Report Type: DA Access Report
Reference Number: 19024
Client: Stema Pty Ltd
Site Address: 28-32 Evan Street, Penrith NSW

ACCESS REPORT

This Access Compliance Report is to accompany a Development Application for the development proposed at 28-32 Evan Street, Penrith NSW.

Typical adaptable unit layout

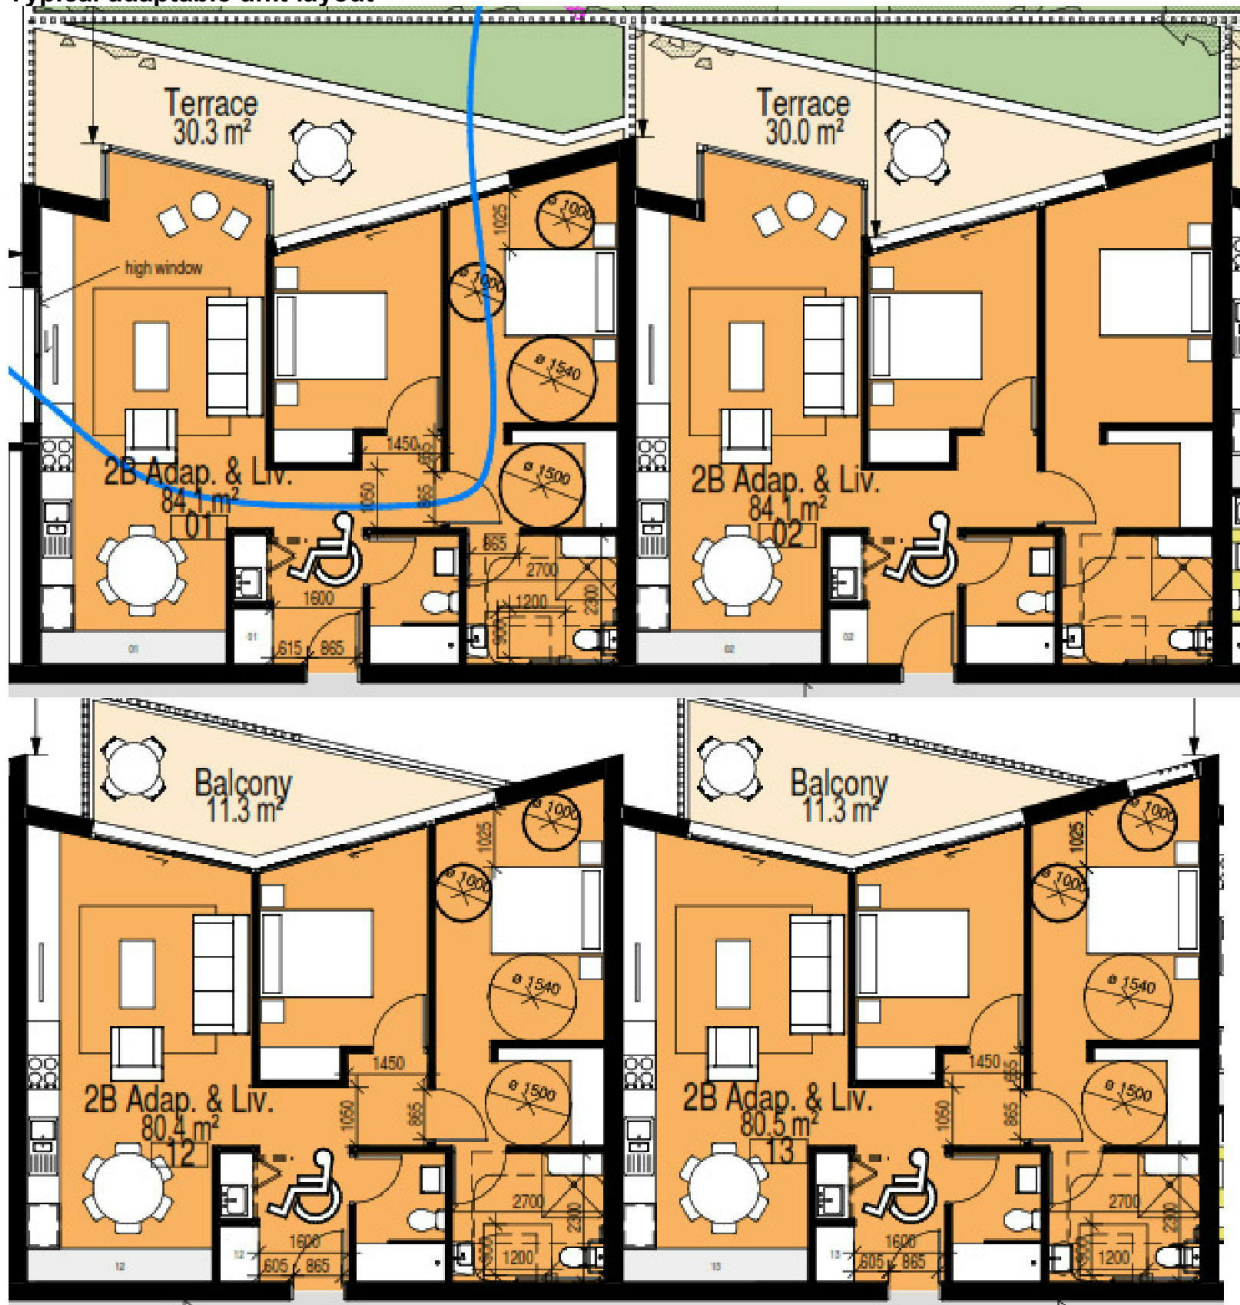
4 Adaptable units are required by the Council's DCP to a Class C level.
The units designated as adaptable are unit numbers **01, 02, 12, and 13**

At DA stage there is insufficient information to certify compliance with the Standard, however, in accordance with the table below, the nominated units can comply with the spatial requirements of AS4299 for Adaptable Housing.

Main Adaptable bathroom

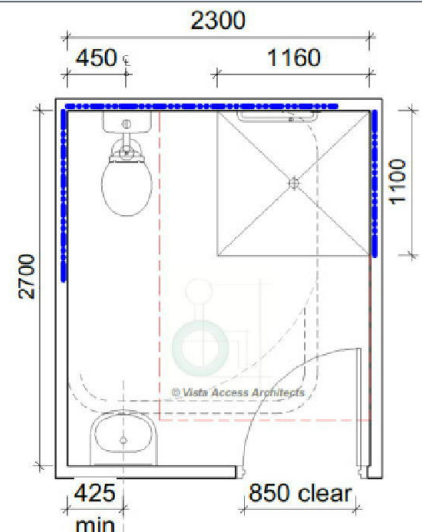
Thick blue line indicates the location of wall reinforcements which are to be provided at pre-adaptation itself. Red dotted line indicates the shower circulation space. Black dotted line indicates the WC pan circulation space.

<ul style="list-style-type: none"> - Provision for bathroom area with Circulation spaces of Shower and WC (including fixtures) to comply with AS1428.1. - Note that wall reinforcements and waterproofing details to comply with AS4299 	<input checked="" type="checkbox"/>	<input checked="" type="checkbox"/>	Complies A bathroom with minimum space of 2Mx 2.95M or 2.3Mx2.7M or 2.4Mx2.45M is achievable. Wall reinforcement details to be verified at the CC stage.
---	-------------------------------------	-------------------------------------	--

Unit 53

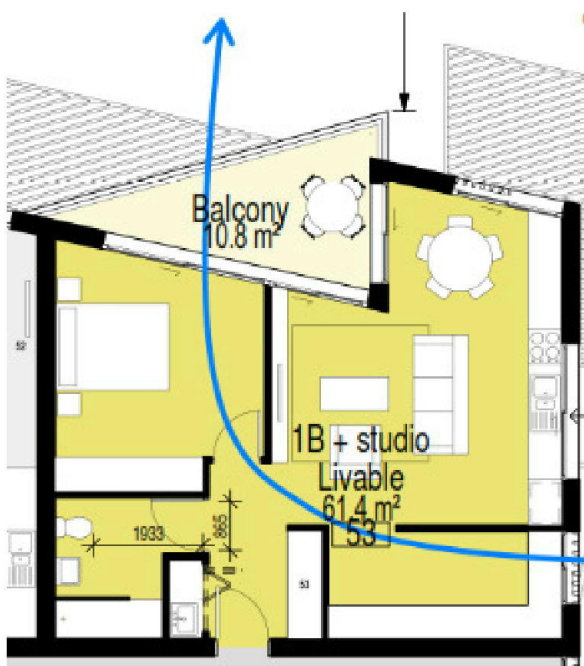
In addition to the adaptable units provided the following 4 units **18, 28, 38 and 53** are capable of providing compliance with the features of Silver level of Livable Housing Guidelines as noted in the table below.
